**NSLPP MEETING HELD ON 7/02/24****Attachments:**

ADDRESS/WARD: 126-128 Willoughby Road, Crows Nest**APPLICATION No:** DA 279/22

PROPOSAL: Alterations and additions to an existing building to create a mixed use development of 2 levels and a mezzanine of commercial and retail premises, and 4 residential units on the upper 2 levels and associated works.

OWNER: DEM Property Group Pty Ltd**APPLICANT:** Ken Demlakian**AUTHOR:** Damon Kenny, Executive Planner**DATE OF REPORT:** 24 January 2024**DATE LODGED:** 16 September 2022**RECOMMENDATION:** Refusal

Figure 4: Section Plan

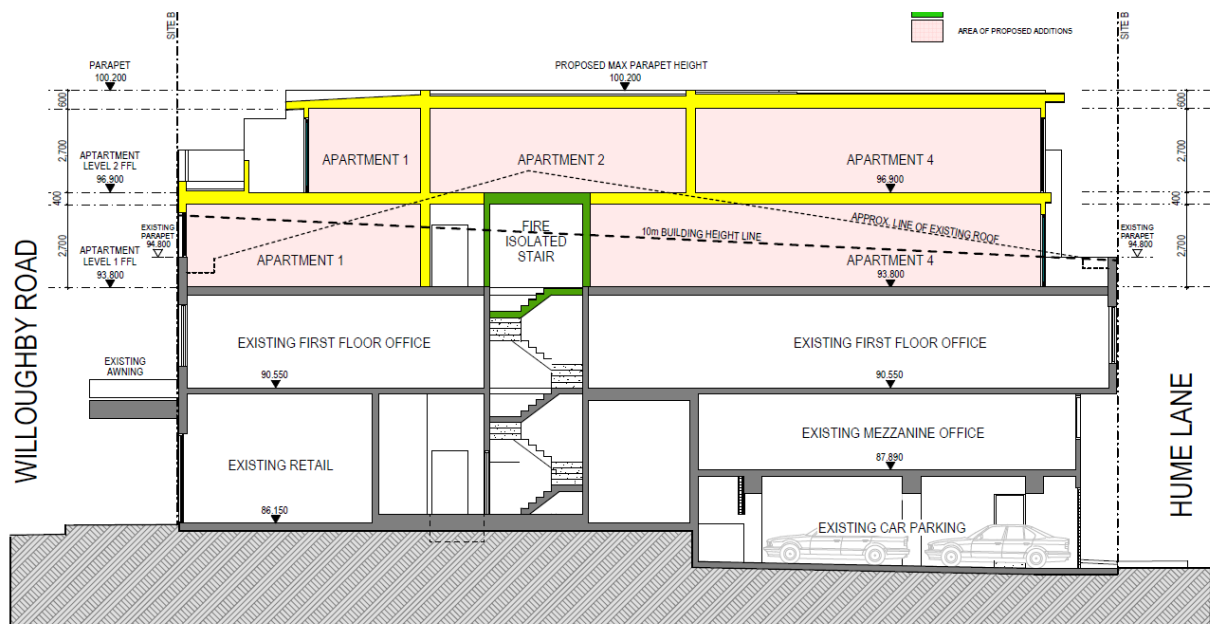
The proposed works would have a height of 16.05m to the lift overrun and 15.45m to the top of the parapet that fails to comply with the permissible height limit of 10m in accordance with clause 4.3 in NSLEP 2013.

However, in the circumstances of the proposed development, this environmental planning ground is not sufficient to justify the exceedance of the height development standard. There is no four-storey building on the eastern and western side of Willoughby Road within the immediate visual catchment of this site with which the proposed development could be said to be consistent. The request does not provide any analysis of how the fourth storey (the additional height) is justified in order to achieve consistency in its context. The reliance, in the written request, on the height of approved buildings elsewhere in the local centre, absent an analysis of the immediate built form context of the subject site or the mechanisms through which those consents were gained, is not sufficient to establish that the additional height is justified to achieve consistency with the context. Although there are streetscape renders elsewhere in the request, there is no accompanying information that establishes that the additional height is justified to achieve consistency in the streetscape context. If anything, the streetscape renders demonstrate that the additional height is not consistent with the Willoughby Road streetscape context, particularly given the two and three storey character buildings located immediately adjacent.

- The avoidance of impacts is an environmental planning ground, as it promotes “good design and amenity of the built environment”, one of the objectives of the EPA Act. However, even that there is no impact from the additional height, the lack of impacts does not arise from the breach of the height development standard so as to justify the breach.
